SUBMISSION AS THE LOCAL PLANNING AUTHORITY

2.2 Comments on submission at Deadline 4

Extract from AS-088

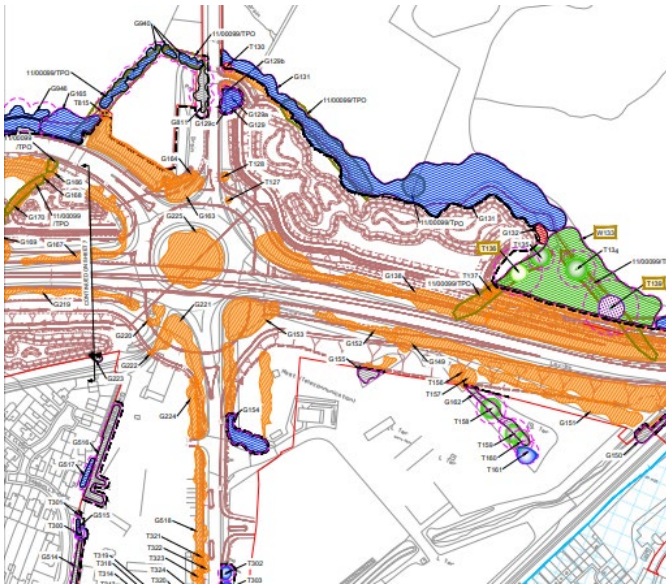
- 2.15.** As can be seen from the extracts below, the amount of trees lost within and around the Cattlemarket roundabout (shown in orange on AS-088) is vast which opens up those views and removes that green infrastructure which makes this area so typically rural in character. AS-026 (below) shows the proposed planting and whilst replacements are proposed, it is our belief that this is not in the correct place or type in which for the applicant to adhere to their own document principles as stated above.
